**AMENDMENT NO. 1 NOVEMBER 1993
TO
IS 8227 (Part 1) : 1988 SPECIFICATION FOR
FASTENERS, ARCH AND CLIP FOR FILES
PART 1 ARCH FASTENERS**

(First Revision)

FIG. 1 DIMENSIONS AND RIVET-HOLES POSITIONS

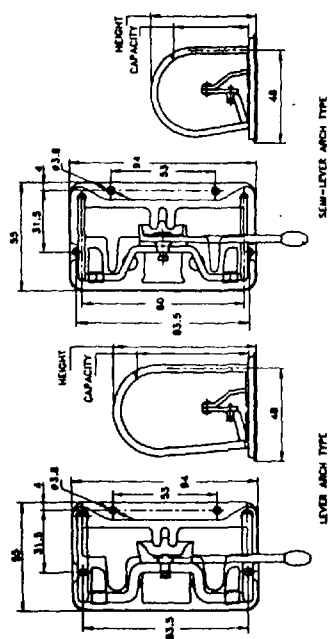
(Page 1, clause 3.5, second and third sentences) — Substitute the following for the existing:

The location of four holes is given in Fig. 1 on next page.

'The base shall have an extension. The extension shall be sufficient to permit the file to be hung against a flat surface. Four holes shall be provided in the base so that it can be mounted on the file board.'
